GEMINI PROJECT

EA Application: Response to Secondary Information Request

MAGNETIC SOUTH

AUGUST 2021

Figure 1: Revised conceptual project layout and location of adjacent sensitive receivers

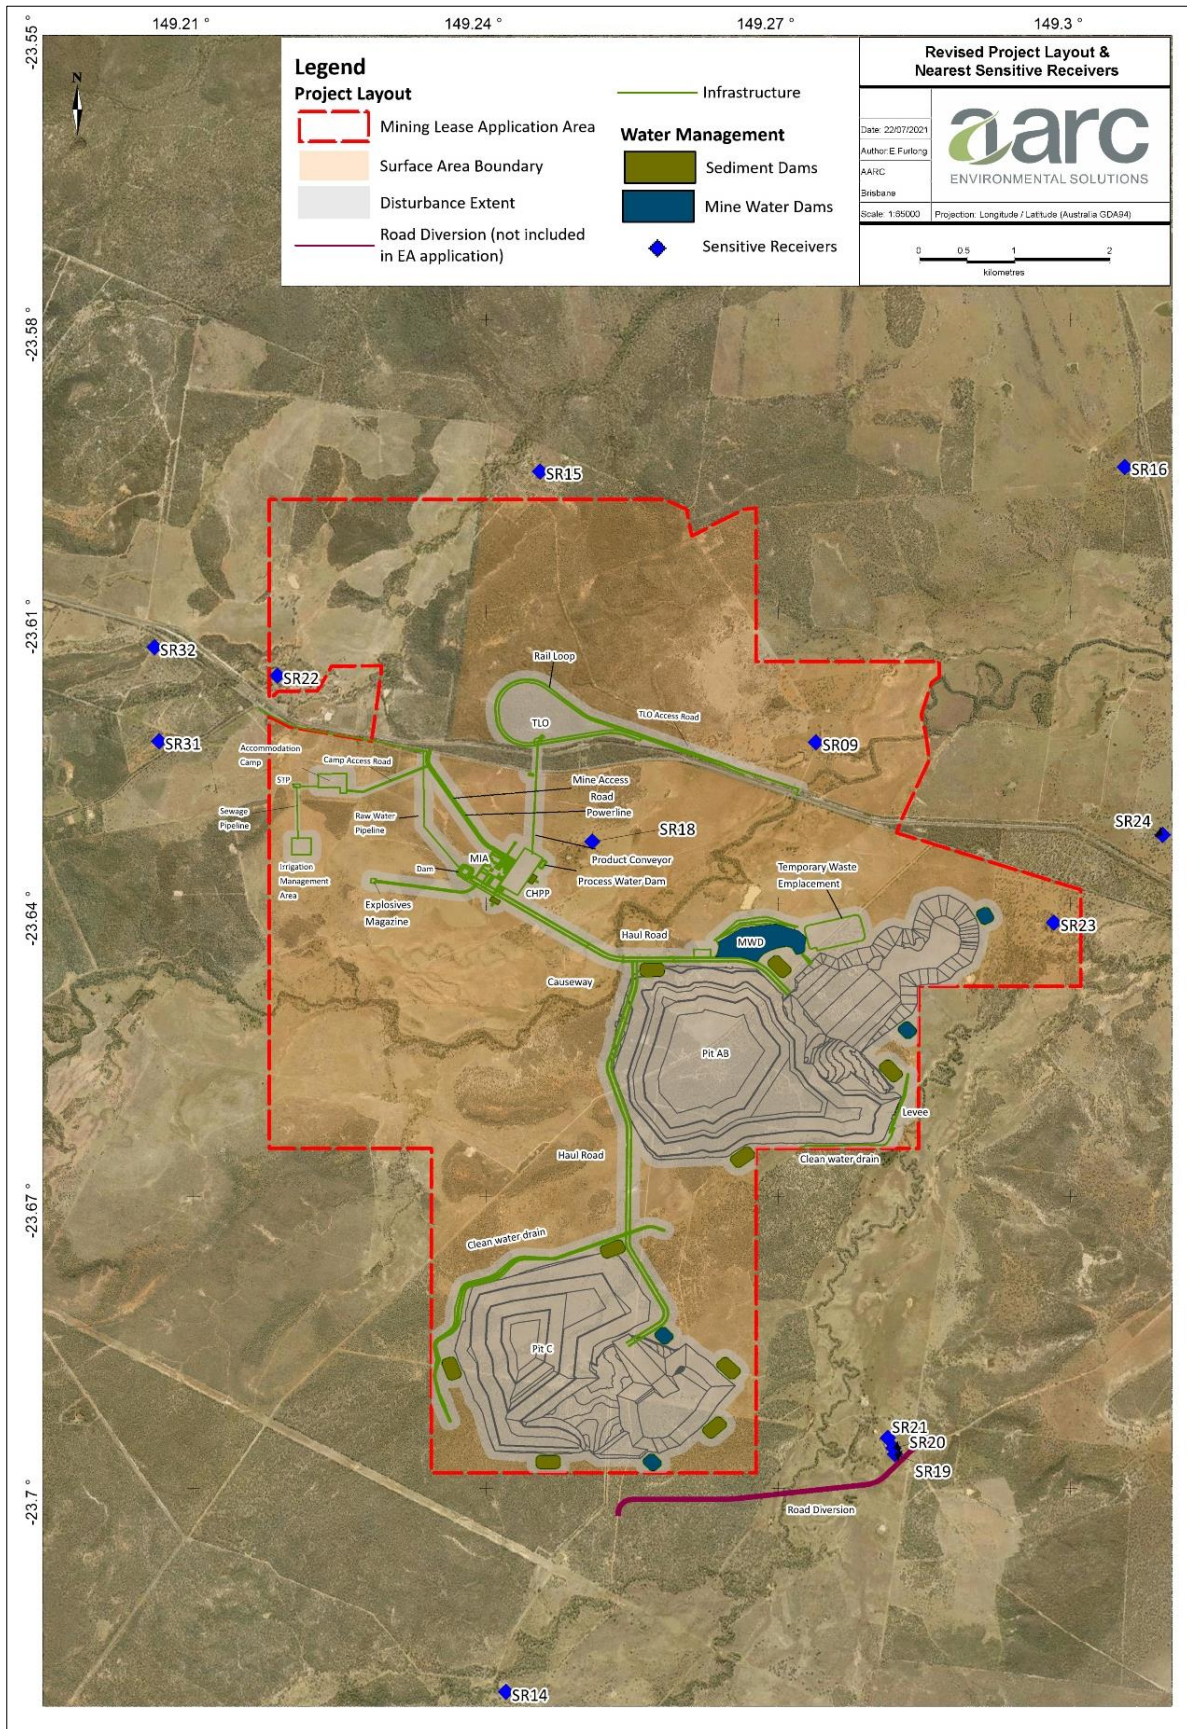
Figure 7 - Conceptual Layout of the Gemini Project shows that the crest of the high wall on the southern end of the Pit AB final void is proposed to extend right to a corner boundary of the tenure, MLA 700056. Table 7 states that a 100 metre buffer has been included around the perimeter of the disturbance footprint, but it is not clear if the buffer has been applied to this part of Pit AB final void area. The Revised Supporting Information does not sufficiently address information requirements, such as, the expected geotechnical stability of the final battered high wall and potential liability of high wall failure. The assessing officer's concern is that as the final landform is proposed to be so close to the tenure boundary, there is a possibility that high wall failure may cause impacts outside of the tenure boundary.

Provide further information to justify the position of the final void for Pit AB with regard to the concerns of creating disturbance and impacts to environmental values (EVs) outside of the tenure boundary. Alternatively, provide a revised conceptual project layout that includes an appropriate buffer between the battered high wall of Pit AB final void and MLA 700056 boundary.

Figure 7 in Section 3.1 of the *Revised EA Application Supporting Information* shows the conceptual project layout, including a 100m buffer within which disturbance may occur (also shown in Figure 1 of this report). The authorised disturbance areas provided in Table 7 include this 100 m buffer. The purpose of this 100 m buffer is to provide design flexibility for activities that may require disturbance beyond the original design infrastructure footprint. This 100m disturbance area has been reduced on the eastern edge of the AB Pit, due to the proximity of the mining lease (ML) boundary. The eastern edge of the AB Pit will be located approximately 50m from the edge of ML during mine operations, and the top of the final battered highwall (following backfill, regrading and rehabilitation activities) will be located approximately 15m from the edge of lease.

These minor changes will not result in significant changes to the mine plan layout and the location of the highwall in relation to the mining lease will remain unchanged to that which is shown in Figure 1.

Figure 2: Location of monitoring bores and water gauge stations

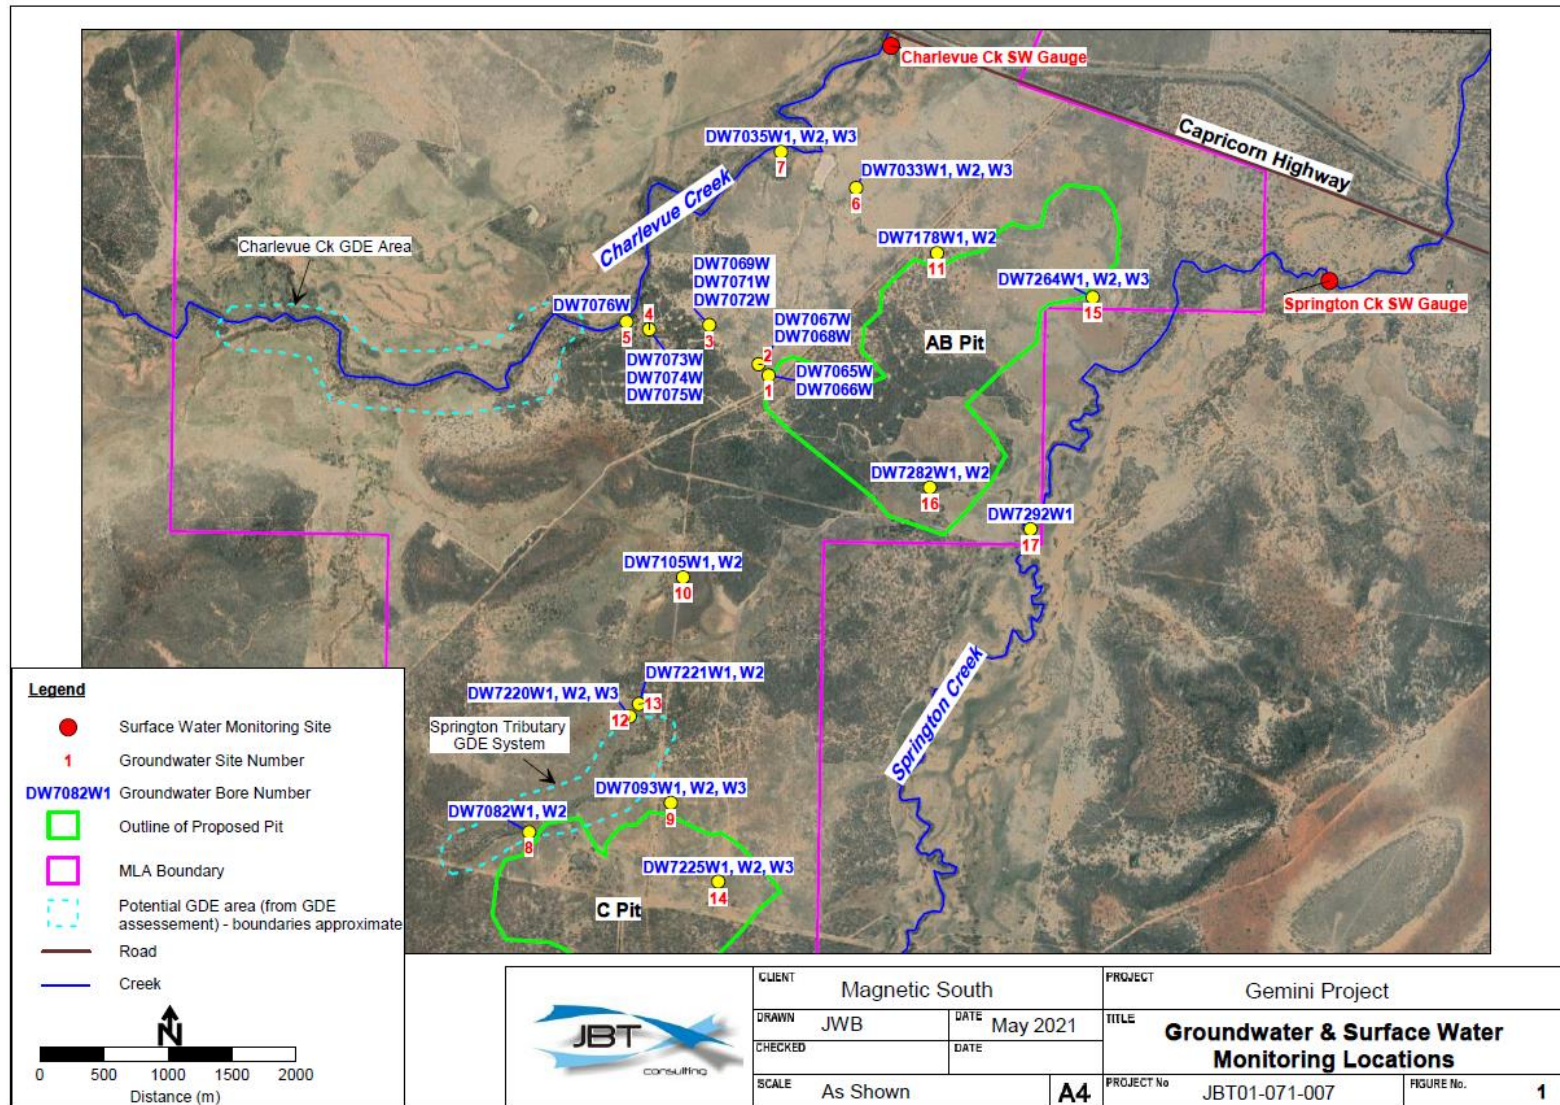
Provide the date of installation of the downstream flow gauging and water quality monitoring stations.

Provide the stream flow and water quality data that has been collected to date.

The location of existing groundwater monitoring bores and surface water gauging stations, along with identified potential GDE areas in the project area, are shown in Figure 2.

Figure 4: Groundwater level in, and base of, Tertiary sediments

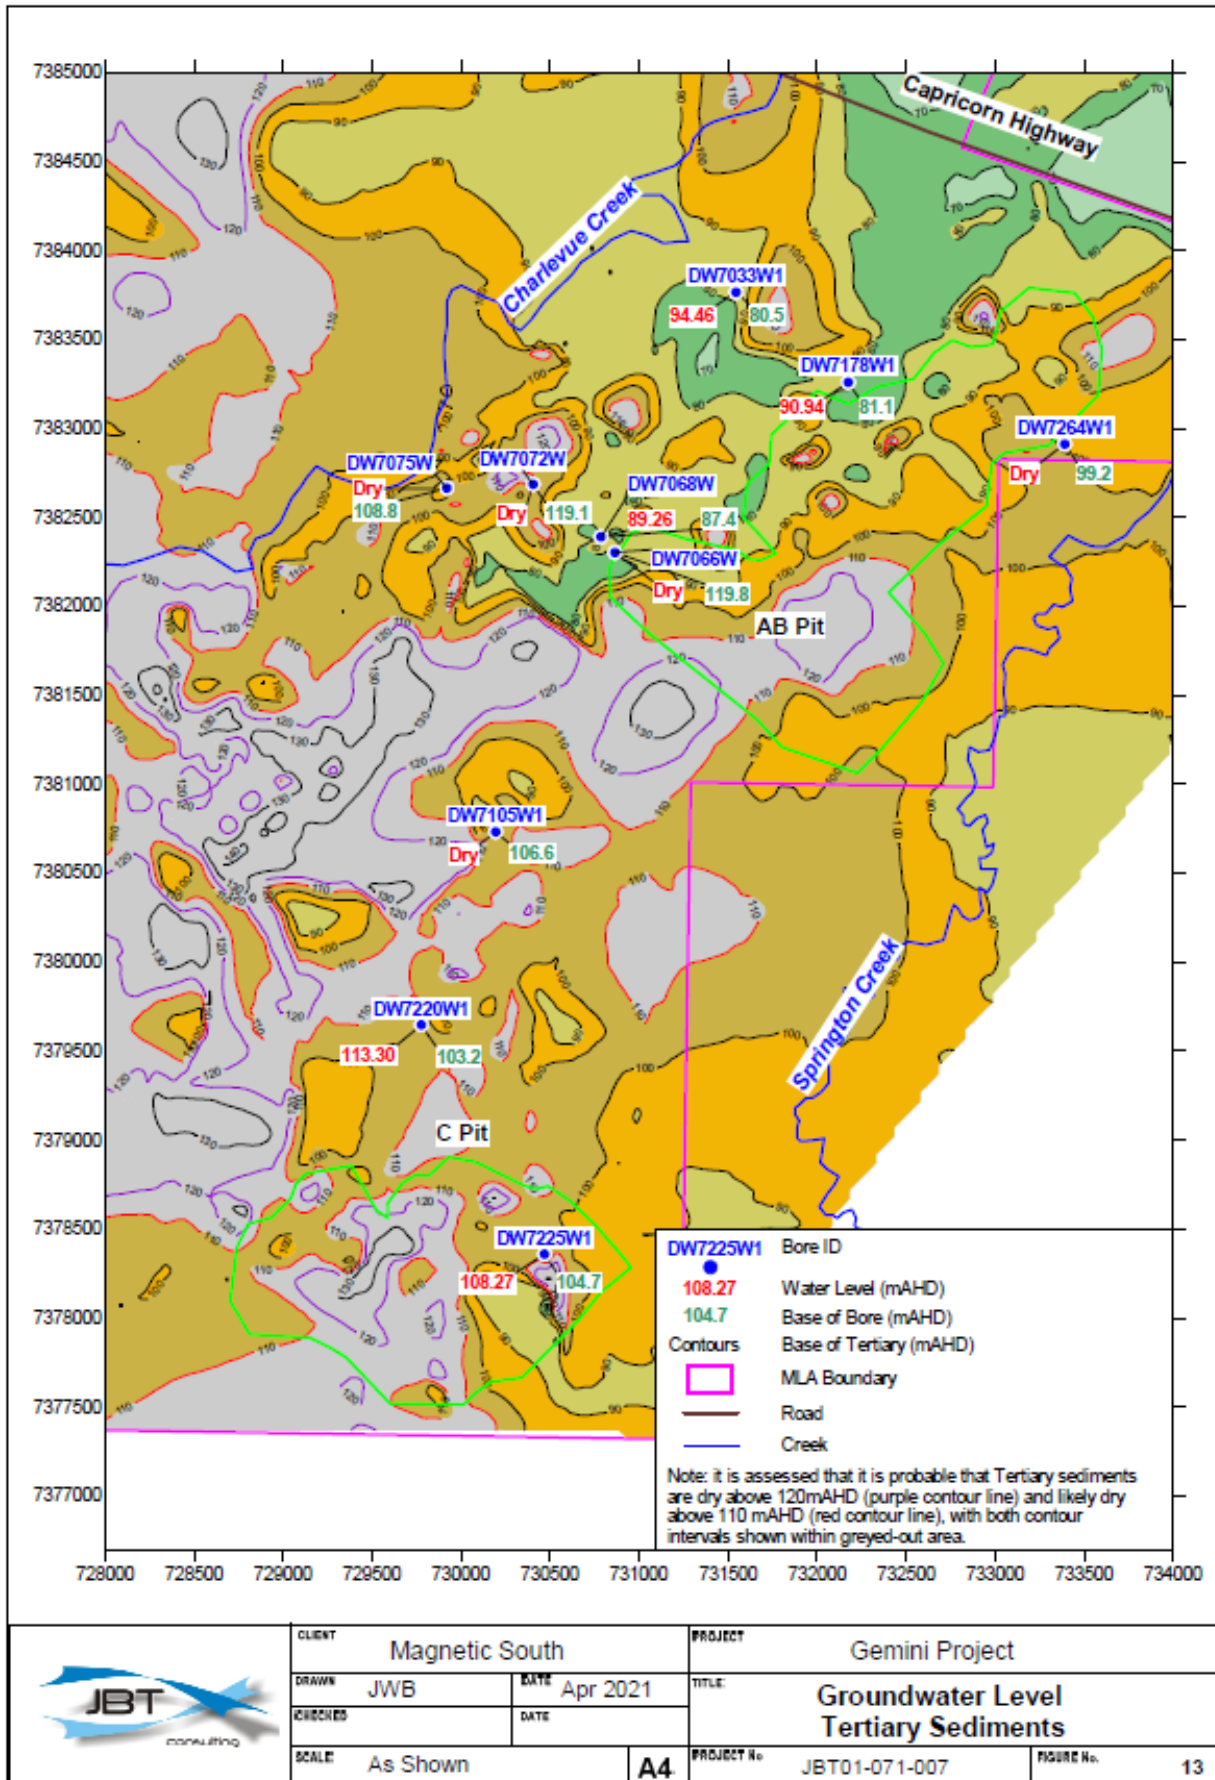
Detailed conceptual understanding of the direction of groundwater flow needs to be demonstrated. Provide a figure illustrating ground water level contours indicating directional flow of groundwater. To demonstrate that the bore network is entirely representative of up and down gradient for each groundwater unit, produce a figure that visualises the ionic chemistry of the groundwater samples, for example, a piper diagram.

A map of the elevation base of the Tertiary sediments (based on data for the site geological model) and the water level data for Tertiary sediment monitoring bores is provided in Figure 4. The Tertiary groundwater system in the ML area is shown to be intersected by a Permian ridge (shown in Grey), which separates the northern and southern parts of the mining lease. The groundwater flow direction in the Tertiary sediments in the ML area is therefore interpreted as being quite localised – moving towards the areas of lower Tertiary base elevation from areas where the preferential recharge occurs (e.g. the area around bore DW7220W1 (refer to Section 2.1.2 of Appendix B. A more detailed analysis is provided in Section 2.1.3 of Appendix B.

Figure 6: Proposed Post Mining Land Use (PMLU) LSC for cattle grazing

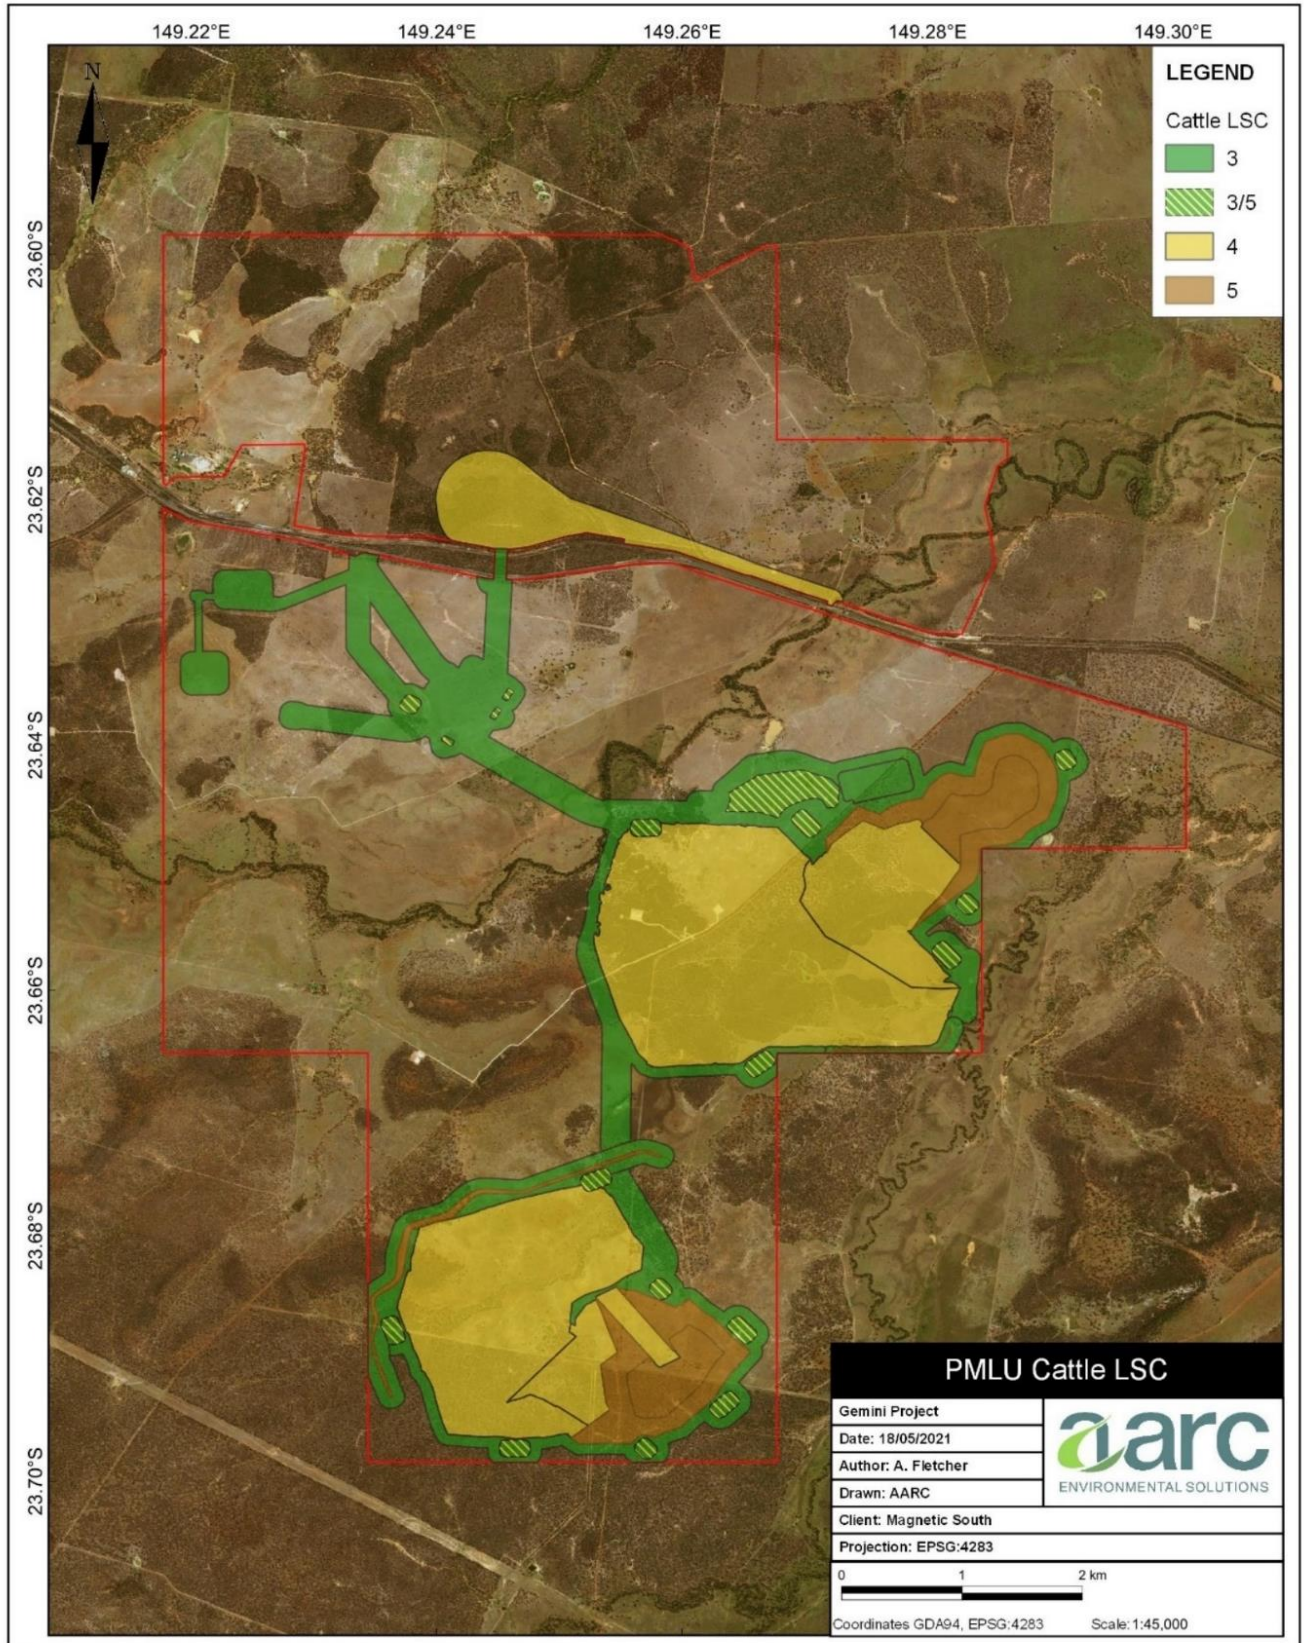
Provide more detailed explanation and acceptance criteria for the post-mining land use “grazing”, particularly:

- The land suitability class/es that will be achieved for areas with a post mining land-use of “grazing”, including if it will return to pre-mining land suitability class or different
- If an area will have a different class to pre-mining, provide justification for how the proposed post-mining land suitability class is appropriate
- If “grazing” will achieve varying land suitability classes in the post-mining landform, provide proposed areas and locations for each class
- Given land suitability classes are assessed against limitations, provide the parameters that will demonstrate that an area has achieved the proposed post-mining land suitability class.

The post mining cattle grazing Land Suitability Class (LSC) proposed to be achieved for each mine domain is shown in Figure 6. This was determined based on the *Land Suitability Assessment Technique* (DME 1995)), with consideration of the pre-mining LSC (refer to Figure 7 SLSA Assessment) and physical characteristics of the post mining landscape, such as topography, recreated soil profiles and the underlying substrate (e.g. mine waste).
